# **Pre-lodgement Meeting Notes**

Application No: PLM2021/0114

**Property Address:** 7 Crown Road QUEENSCLIFF

**Proposal:** Alterations and additions to an existing dwelling house

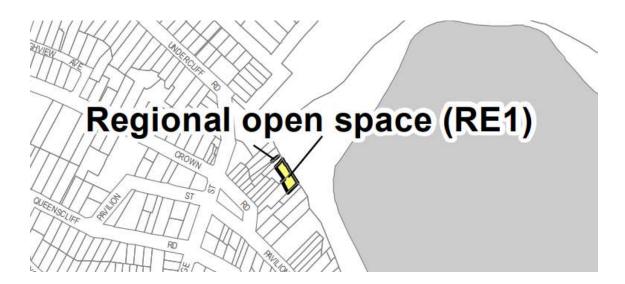
In regard to the portion of the site that is zoned RE1 Public Recreation, this portion of the land is also subject to Clause 5.1A *Development on land intended to be acquired for a public purpose* of WLEP 2011. It is Council's intention to acquire this land for Regional Open Space, as shown on the map below:

The only permissible land uses on this part of the site would be "Earthworks" and "Recreation areas". From the information provided, it is likely that no works are proposed in RE1 zoned part of the site, hence no prohibition is triggered.

In the context of any future development on the land (including the proposal presented in this PLM), the calculation of any planning standards and controls would be from only the land that is zoned for residential purposes and not that part of the site that is zoned for public open space and subject to future purchase. This is predicated on the intention that part of the site will be eventually purchased and not available for future development.

Of most relevance to the proposal in this regard is the rear setback as it would apply to the northern boundary and the calculation of landscaped open space on the future intended boundaries of the site.
